QST JAN 11 WATTMETER

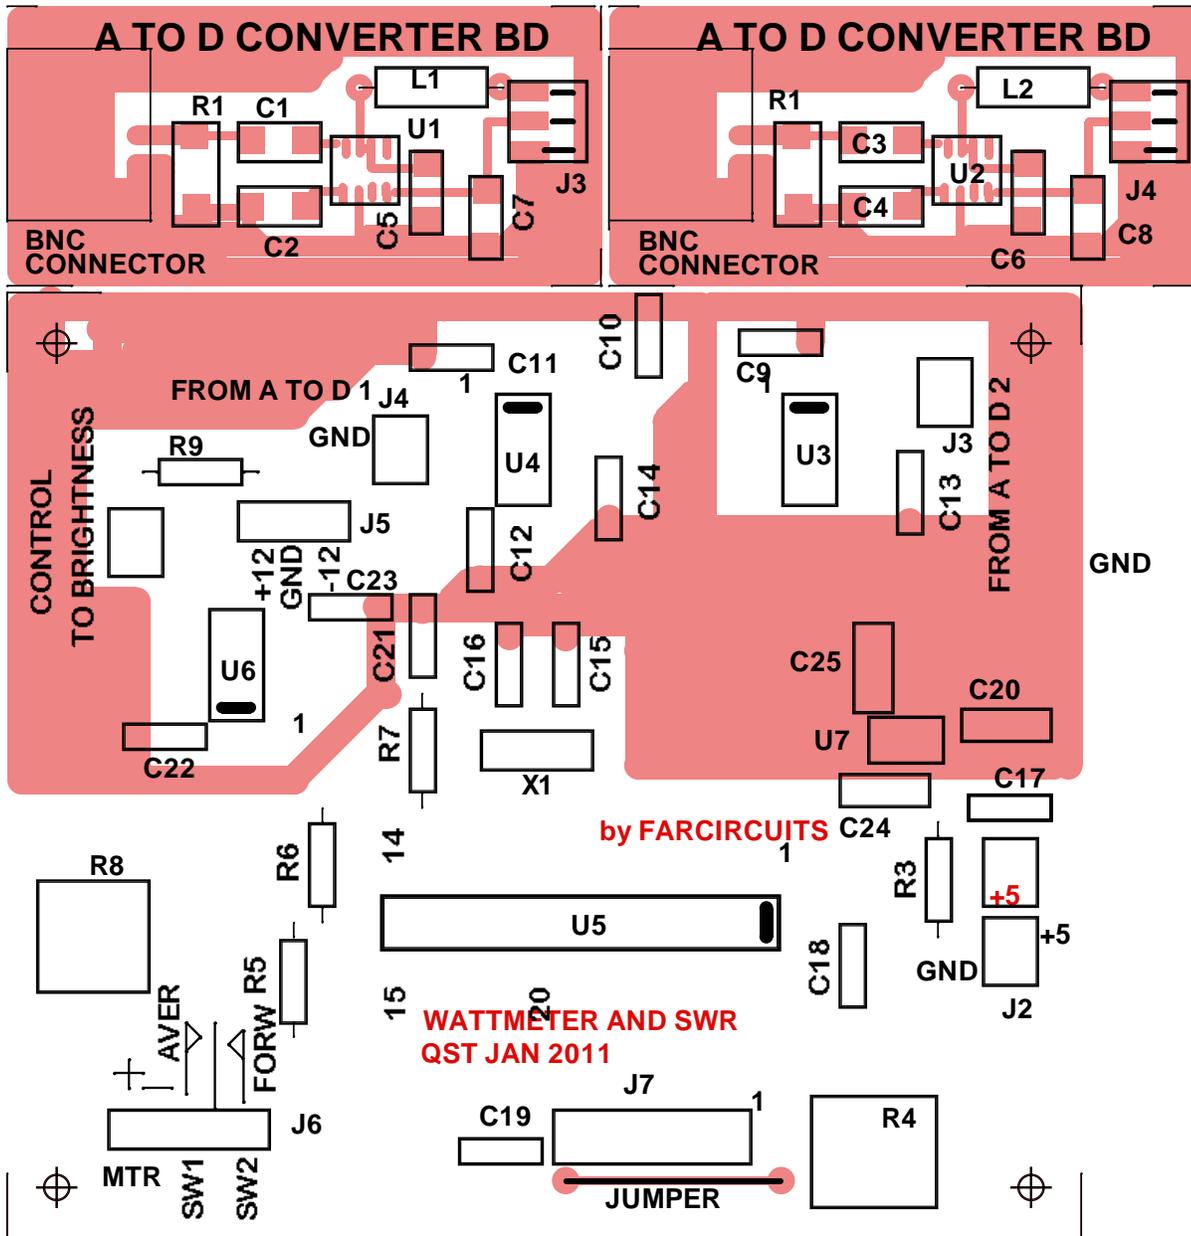
TWO A TO D CONVERTER BD REQUIRED

NOTE: U7, C20, C24, AND C25 ARE MOUNTED ON THE BOTTOM OF THE BOARD

NOTE: THE SCHEMATIC IN QST SHOWS TWO R1 RESISTORS, AND NO R2 ONE OF THESE R1'S IS R2

THE PARTS LIST, R1 AND R2 AND THE SAME VALUE
